Access Compliance Report

Public Rights-of-Way

(Pedestrian Signals)

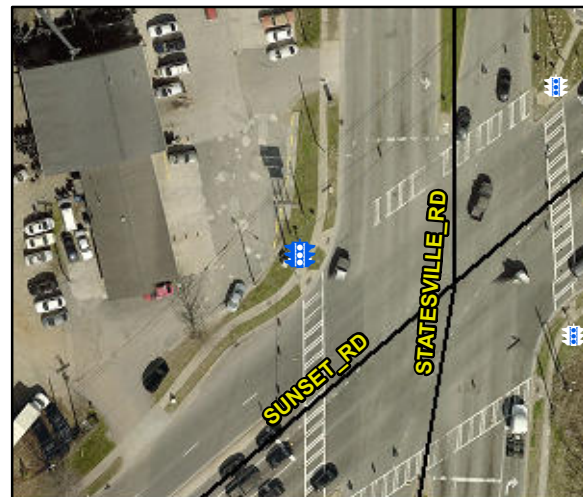
Surveyor Notes: TX HT 5/16 BOTH BUTTONS

PROW/ADA: R410.6, R209.1, TMUTCD 4e.08, R406.2, R404.7.3

Possible Solutions: Replace Signal Push Button With APS Button on New Post. Remove & Replace Sign.
